V2500 Propulsion System — Nacelle

SERVICE BULLETIN

V2500-NAC-71-0098

NACELLE - EXHAUST - GUIDE PIN, NO.1 OPEN LATCH INDICATOR, THRUST
REVERSER - REPLACEMENT OF

NO. 1 Open Latch Indicator Assembly Removal And Installation
Figure 1

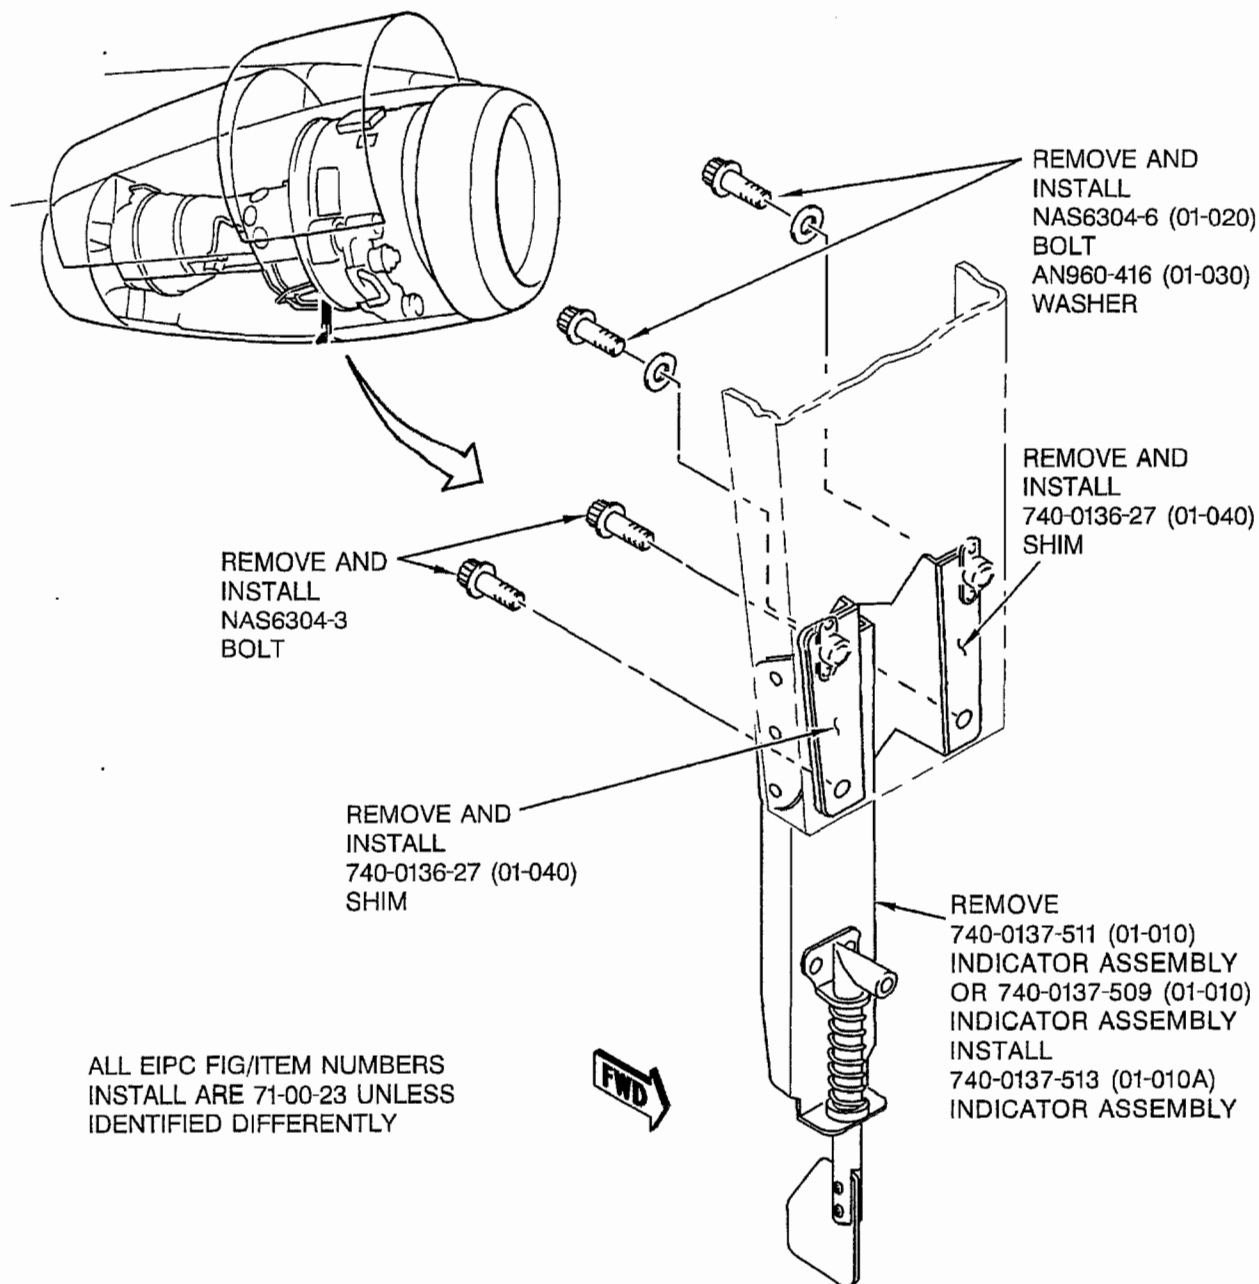
- (1) Remove the No. 1 open latch indicator assembly.
 - (a) Remove the two NAS6304-6 bolts and AN960-416 washers, two NAS6304-3 bolts, 740-0137-509 indicator assembly, and the 740-0136-27 shims from the engine. Keep the bolts and shims. Refer to Figure 1.
- (2) Install the No. 1 open latch indicator assembly.
 - (a) Install the 740-0137-513 indicator assembly and 740-0137-27 shims on the engine with the two NAS6304-3 bolts, two NAS6304-6 bolts, and AN960-416 washers. Tighten the NAS6304-3 and NAS6304-6 bolts to a torque of 50-70 in-lbs (5.649-7.909 Nm).

- (1) Remove the No. 1 open latch indicator assembly.
 - (a) Remove the two NAS6304-6 bolts and AN960-416 washers, two NAS6304-3 bolts, 740-0137-511 indicator assembly, and the 740-0136-27 shims from the engine. Keep the bolts and shims. Refer to Figure 1.
- (2) Disassemble the No. 1 open latch indicator assembly.
 - (a) At the top end of the guide tube, drill out the two MS20427M5-5 rivets that attach the guide tube bracket to the indicator assembly with a 0.161-0.165 inch (4.089-4.191 mm) drill. Refer to Figure 2.
 - (b) Remove the guide tube, with the indicator flag and the

- (5) Install the No. 1 latch indicator assembly.
 - (a) Install the 740-0137-513 indicator assembly and 740-0137-27 shims on the engine with the two NAS6304-3 bolts, two NAS6304-6 bolts, and AN960-416 washers. Tighten the NAS6304-3 and NAS6304-6 bolts to a torque of 50-70 in-lbs (5.649-7.909 Nm).

Open Latch Indicator Disassembly
Figure 2

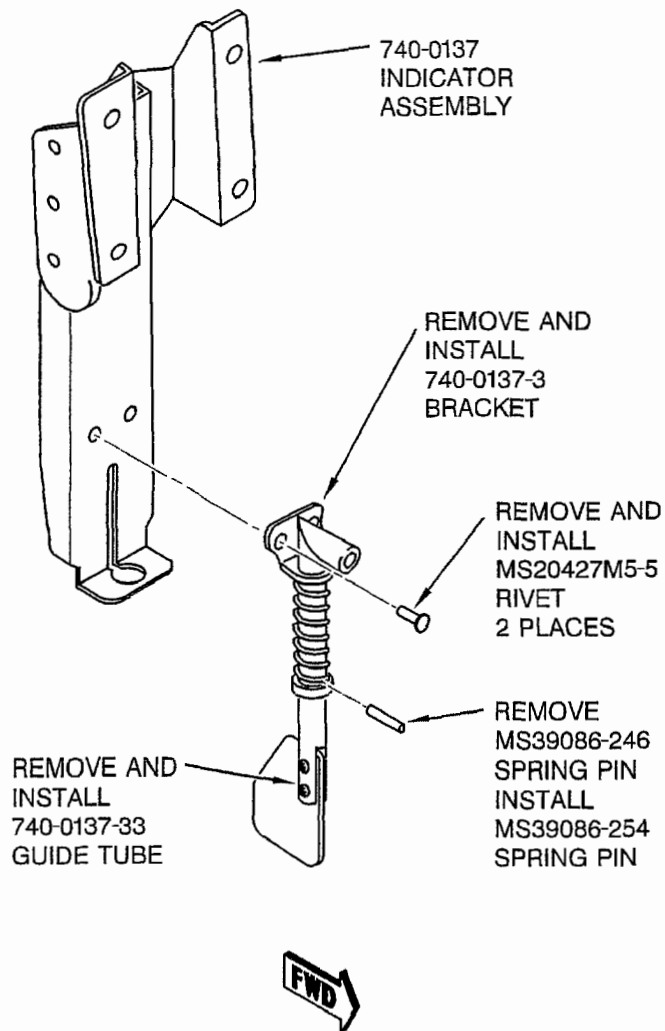
- (4) Assemble the No. 1 open latch indicator assembly.
 - (a) Install the guide tube into the indicator assembly. Refer to Figure 2.
 - (b) Put the guide tube bracket against the indicator assembly and align the rivet holes. Hold the bracket in position.

Spring Pin Installation
Figure 3

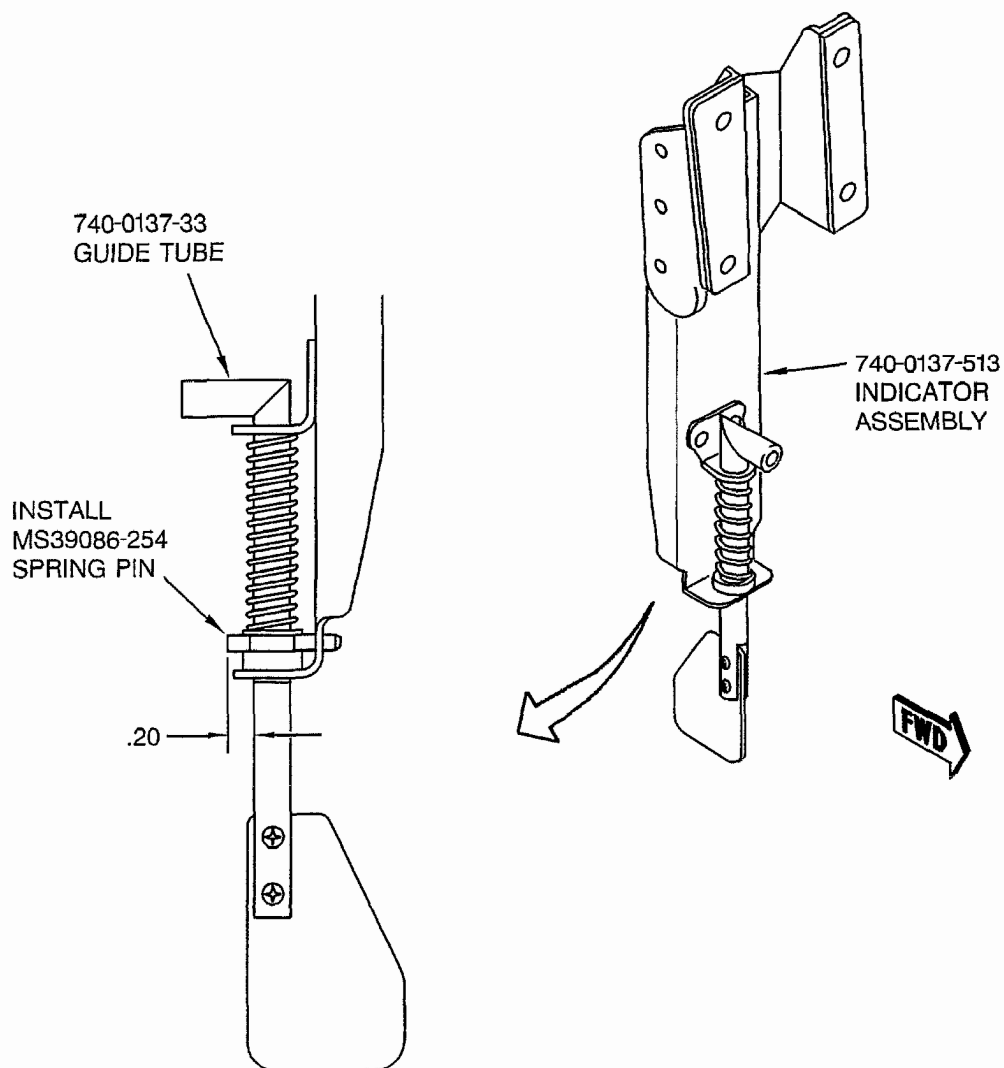
- (3) Replace the guide tube spring pin.
 - (a) Compress the guide tube spring between the guide tube bracket and the AN960D616 washer and temporarily hold in place with safety wire.
 - (b) Remove the MS39086-246 spring pin from the guide tube.
 - (c) Increase the diameter of the two spring pin holes in the guide tube to 0.185-0.192 in (4.699-4.877 mm). Remove the burrs from the holes.

- (d) Clean the spring pin holes in the guide tube with a lint free cloth (CoMat 02-099) and trichloroethane (CoMat 01-001). Wipe the surface dry before solvent becomes dry.
- (e) Install a MS39086-254 spring pin into the guide tube. Make sure the spring pin separates the AN960D616 washer and 740-0137-9 spacer on the guide tube. Make sure the spring is in the correct position in the guide tube. Refer to Figure 3.
